## Portable Oxygen Generating System (POGS33C)

**Technical Bulletin Number:** TB 5-9-08-1

**Reference:** Generator Motor Pulley for POG 33C Feed Air Compressors

**Technical Bulletin Number:** TB 5-9-08-2

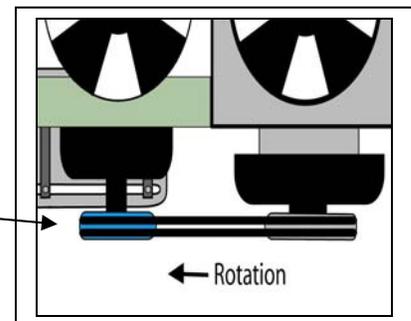
**Reason for Change:** To ensure oxygen pressure is maintained, while at the rated flow, at altitude. A design change to the PowerEx scroll compressor (part number SLAE05E) affects the compressor's output curve (RPM to Output). There is NO IMPACT TO OXYGEN PURITY OF 93% +/- 3% OR FLOW RATE. There may be a slight decline in oxygen pressure from the specified 50 +/- 2 PSI to between 45-47 PSI, at higher elevations when at maximum flow for the elevation. This lower pressure does not affect oxygen for patient delivery via cannula or cylinder filling. It may cause ventilators or anesthesia units operated using oxygen as the driving gas to alarm due to low pressure.

**Details of Change:** Compressor motor pulley size changed from 4.5" to 5".

<b>Part No:</b>	<b>Description</b>	<b>Quantity</b>	<b>Comments</b>
2-3V4.50	Pulley (4.5")	One	Replaced with 2-3V5.0 (5")

## Removal of 4.5" pulley

- Open the Compressor Interior Cover.
- Using a  $\frac{9}{16}$ " wrench, loosen the four mounting nuts securing the Compressor Motor mounted to the frame.
- Using a  $\frac{3}{4}$ " wrench, turn the bolt on the lower left of the frame counterclockwise to loosen the belts.
- Remove the belts.
- Using a  $\frac{1}{8}$ " Allen wrench loosen the set screw on the pulley.
- Remove the bolts on the pulley one at a time and place them in the threaded hole that is to the right of the one just exited.
- Do this for all 3 bolts.
- Tighten the bolts one at a time until the shaft hub separates from the pulley. Remove the shaft hub, shaft key, and the pulley.
- Remove the three bolts from the shaft hub.

## Install the 5" pulley

- Trial fit the pulley to the shaft hub, this is a tapered shaft and the pulley must be installed with the larger hole against the shaft hub.
- Slide the pulley and shaft hub with shaft key onto shaft leaving  $\frac{1}{2}$ " of shaft showing.

- Install the 3 bolts in the non-thread hole of the shaft hub, align to the threaded hole in the pulley, and tighten.
- Install the belts and the check belt alignment and adjust pulley as necessary.

- Tighten the set screw on the pulley.
- Using a  $\frac{3}{4}$ " wrench, turn the bolt on the lower left of the frame clockwise to tighten the belts.
- Apply approximately 10 pounds of force at the mid-span of the belt between the pulleys. The belt should deflect  $\frac{1}{2}$ " to  $\frac{3}{4}$ ".

- Adjust belt tension to  $\frac{1}{2}$ " to  $\frac{3}{4}$ " deflection and tighten the four mounting nuts.
- Close the Compressor Interior Cover.
- Connect the power and start the feed air compressor.
